K-14/D029

Re: Certification Submittal for Permanent Building Certificate of Occupancy for Silver Gardens Phase 2 [K-14 / D099]
100 Silver SW
Architect's Stamp Dated 11/30/11

Re: Silver Gardens Phase II, 100 Silver Ave SW,
Request for Permanent C.O. - Approved
Engineer's Stamp dated: 06-06-2011, (K-14/D099)
Certification dated: 11-29-11

Re: Silver Gardens Grading and Drainage Plan
Engineer's Stamp dated 9-17-08 (K14/D99)

SILVER GARDENS
100 SILVER AVE
PHASE 2

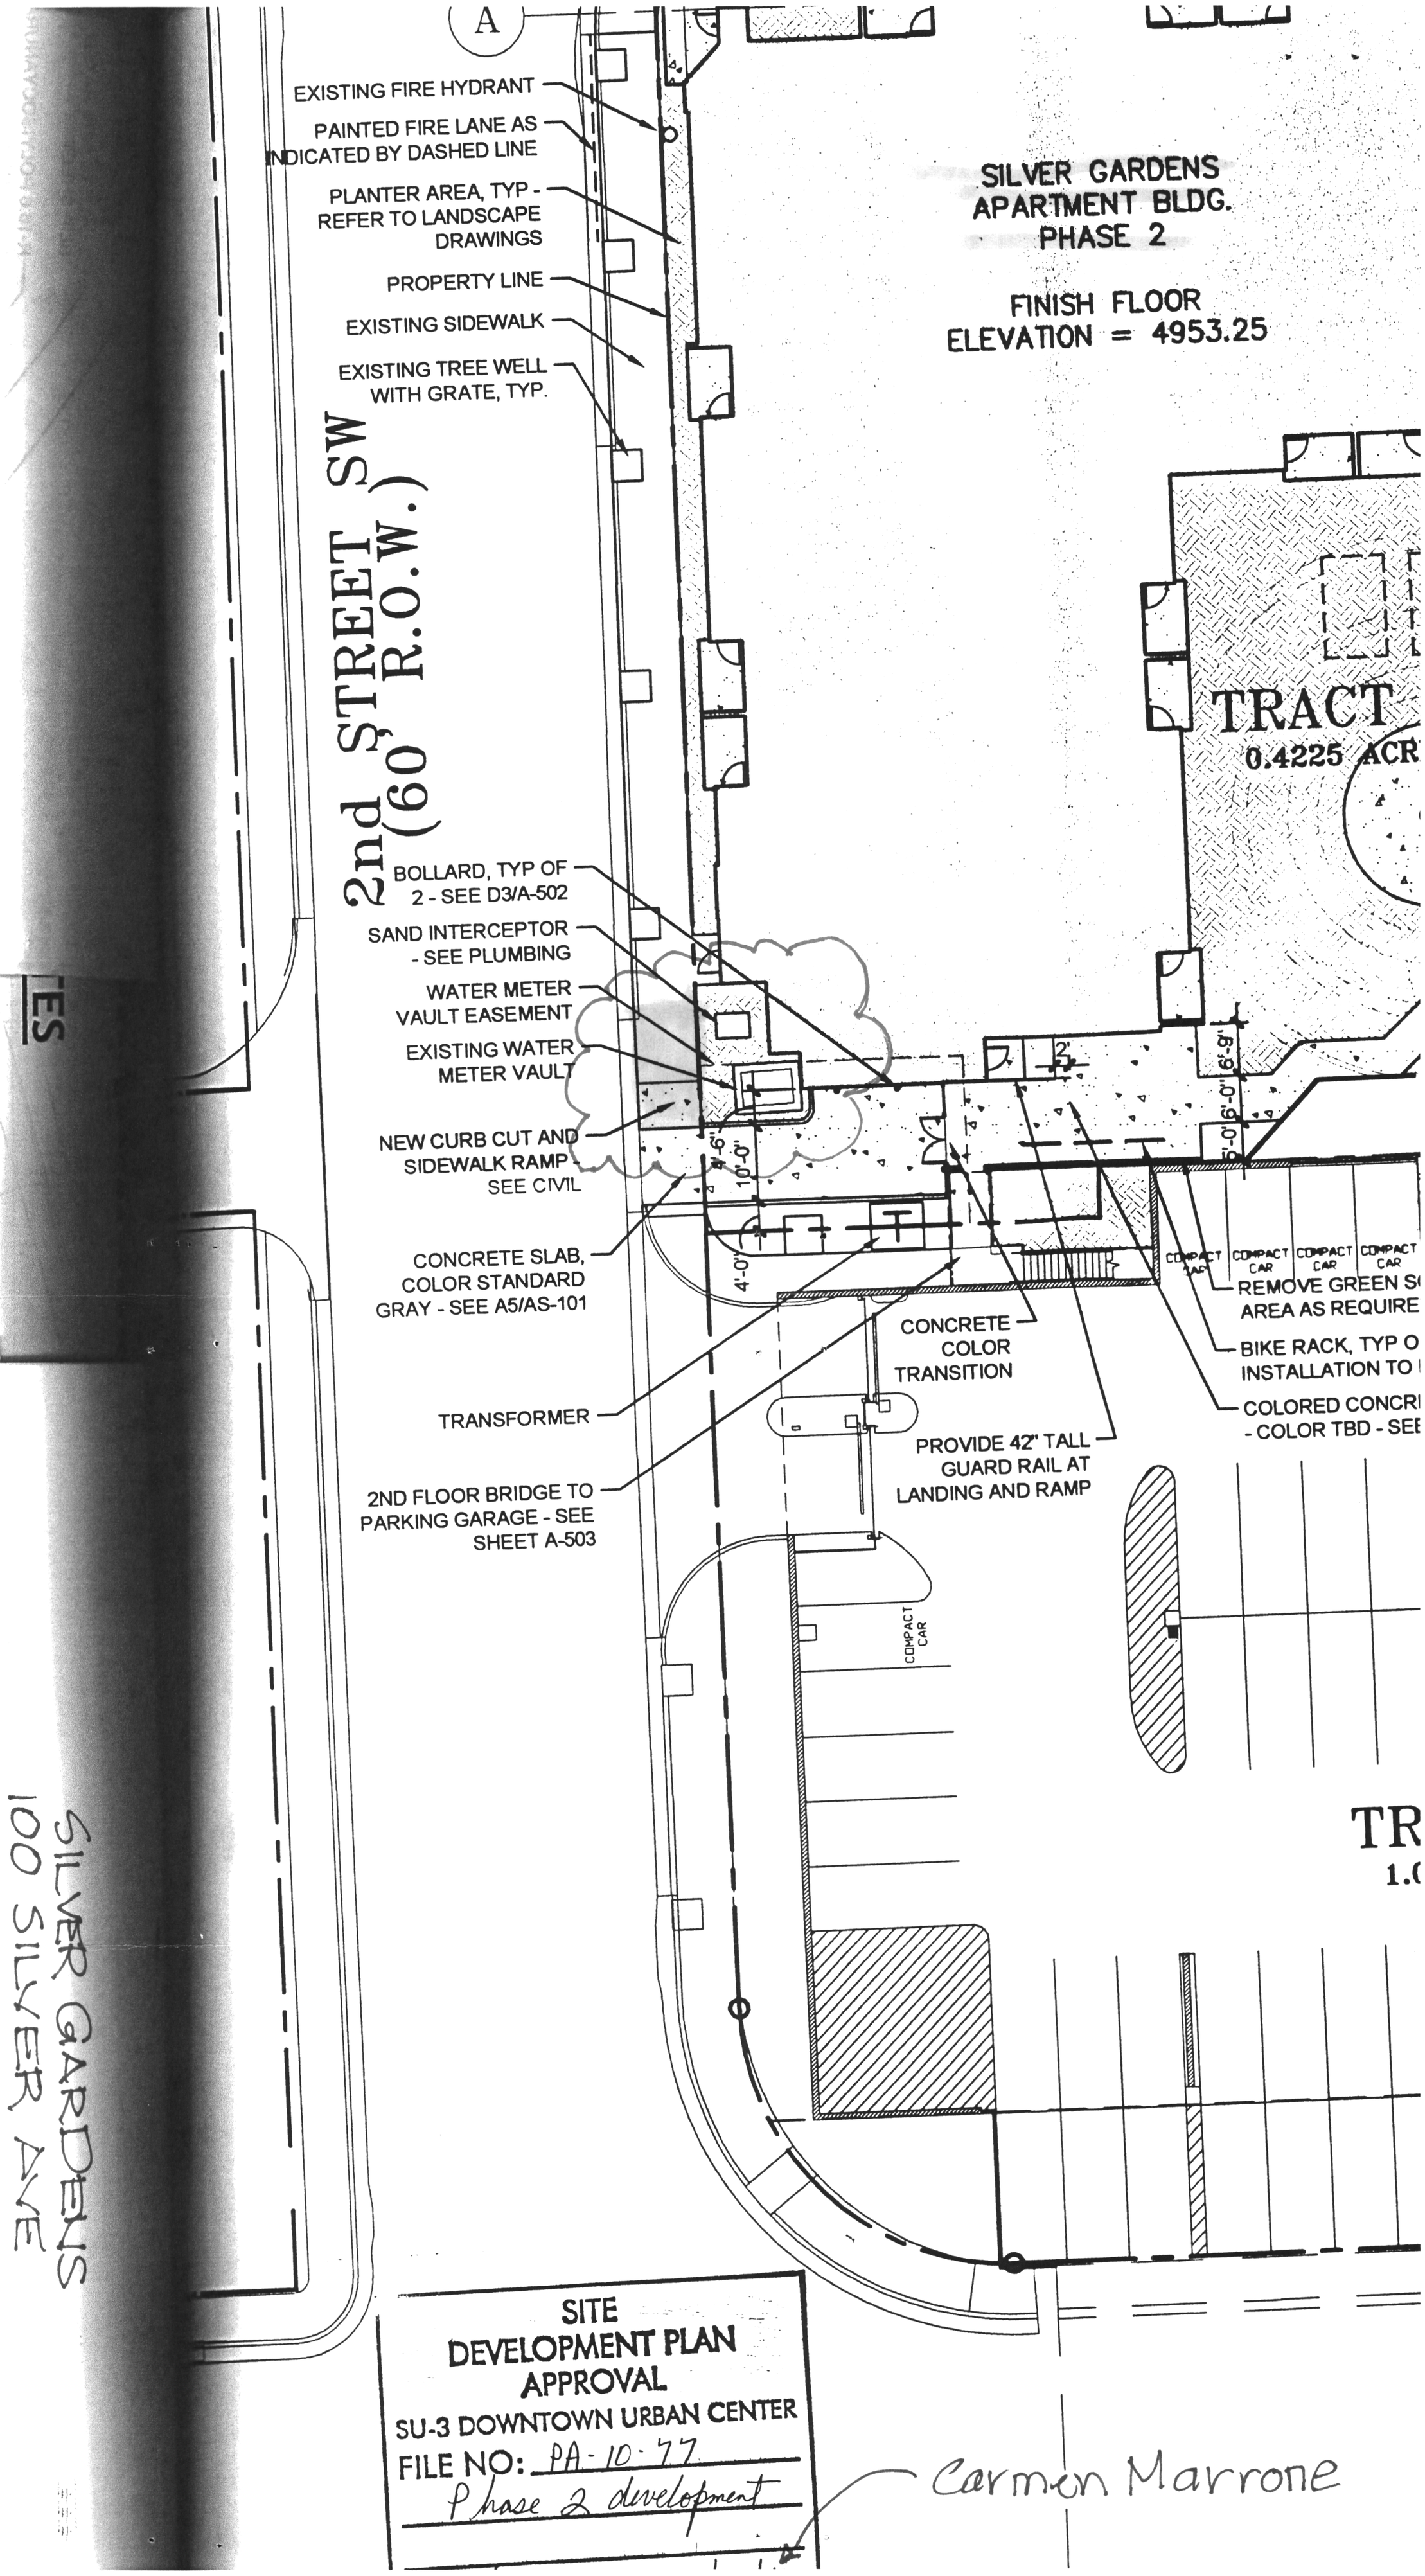
water meter doors must open fully as intended

OK

DETAIL F

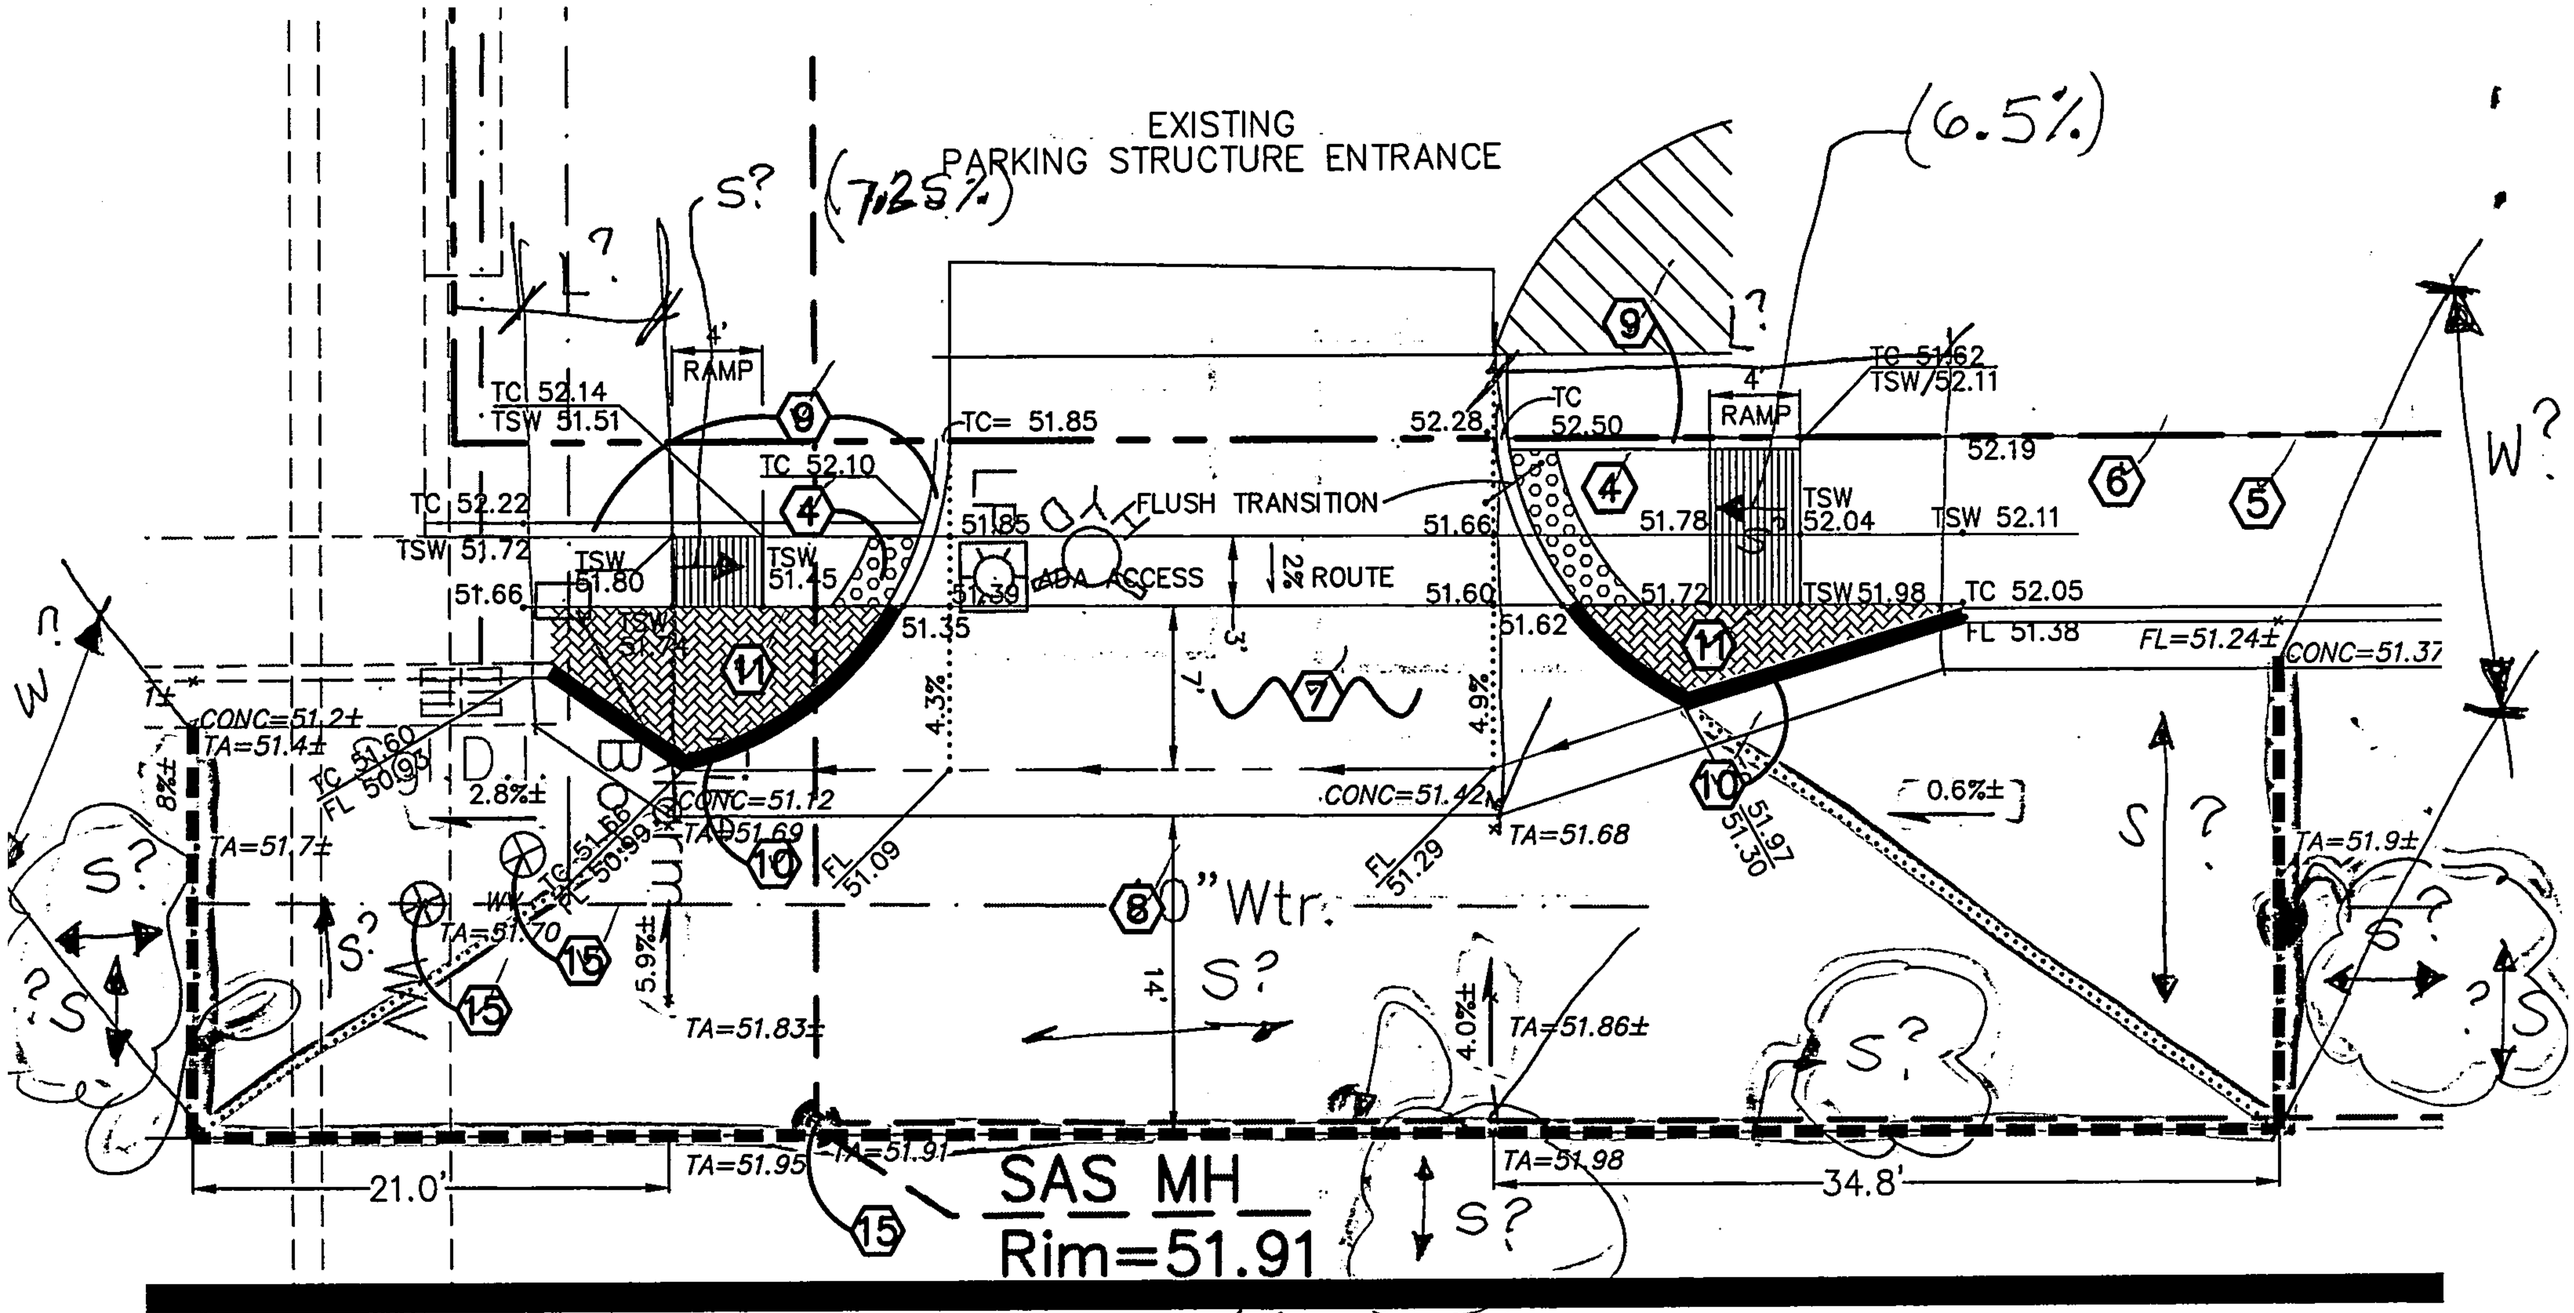
1. what are the tie in slopes on the N, S & E side of proposed pvmt. R/R Limits (x-slope & profile slopes)

- What are the tie in slopes (x-slope & profile slopes) on the north, south and east side and beyond the proposed limits of the pvmt. r/r(provide extra info)?
- Otherwords, provide a x-slope and profile grades/slopes on and beyond (50-60 ft on each approach) to ensure proposed design doesn't interfer with vehicle pathway (smooth transition from existing through proposed to existing pavement {without losing much of the vehicle speed}).
- The width and length for the over all pavement work need to be provided.

I am curios that no additional asphalt must be removed at the north end (entrance)? That end seemed steeper.

Paul have Genny provide a cross section verifying that there wouldn't be any issues (issues for the asphalt pavement: longitudinal and lateral for vehicle pathway) for the roadway. If there are any issues, then solutions need to be provided.
Nilo

Attached is the exhibit showing my proposed extents of asphalt removal and the slopes it will create at various locations. Please contact me when you've had a chance to review it.

After looking over the shots that Bob got for me this morning, I found that pulling the flowline back 4' as Bob requested still leaves us with the possibility of scraping bumpers. If the additional 8' of asphalt is removed as called out on the change order sheet, back bumpers will clear the asphalt.

The entry should be built as called out on the change order, with one exception. Please extend the limits of the removal an additional 4' to the south. This will make the transition from the FL at the south bump-out back to existing asphalt about 8%.
